Planning Board – July 24, 2017, 6:30PM
City Hall Council Chambers – 3 Washington Street, 2nd floor

4. **SPR-578, Mod. 1 – 219 West Street – Mobil Gas Station – Site Plan** – Applicant/Owner Summit Distributing, LLC proposes re-development of a gas station/convenience store/canopy/underground fuel storage and shifting of Ashuelot Street driveway. The site is 18,240 sf in size and located in the Commerce Zoning District (TMP# 098-02-014).

219 West Street

SCALE: N.T.S.	DATE: JUNE 16, 2017	DRAWING NO.
DRAWN BY: NKG	CHECKED BY: HS	PROJECT NO.
		403116
		10 OF 10

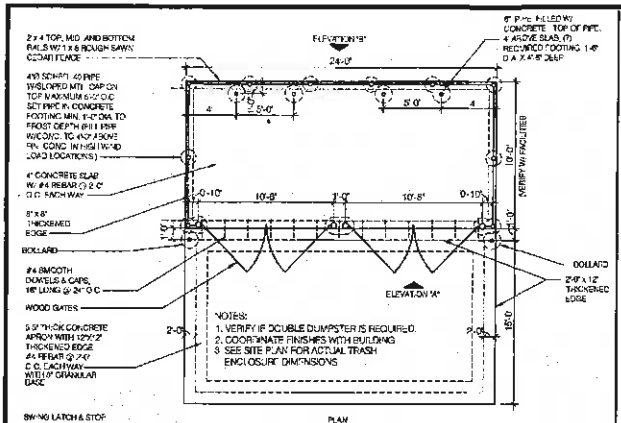
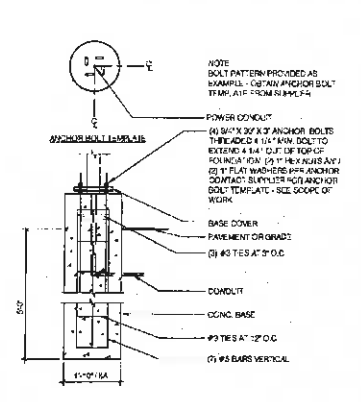
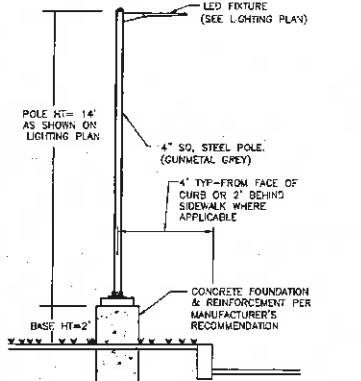
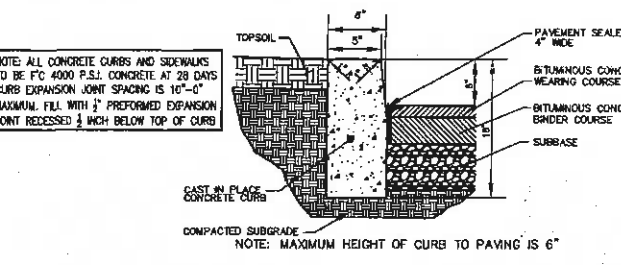
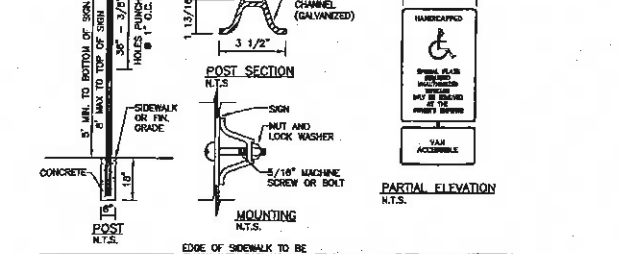
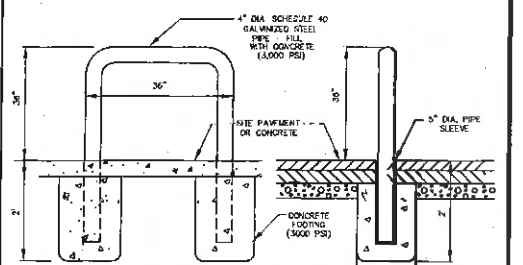
4. Sheet 9 of 10, granite curbs to be set on gravel; the City requires granite curb to be set in place with class B concrete per City standard detail. Curbs within the Right-of-Way shall comply with this standard. Curbs on site may be set in gravel at the owner’s discretion.

5. Sheet 9 of 10, concrete sidewalk details depicts wire mesh with 3000 psi, and steel reinforcement with 4000 psi. The City requires all cast-in-place concrete sidewalks to have a compressive strength of 4000 psi and fiber reinforcement.

Applicant response: Sheet 9 of 10 has been revised to show the City of Keene Standard Detail for vertical granite curb and concrete sidewalks in the right-of-way.

Applicant response: Sheet 9 of 10 has been revised to show the City of Keene Standard Detail for vertical granite curb and concrete sidewalks in the right-of-way.
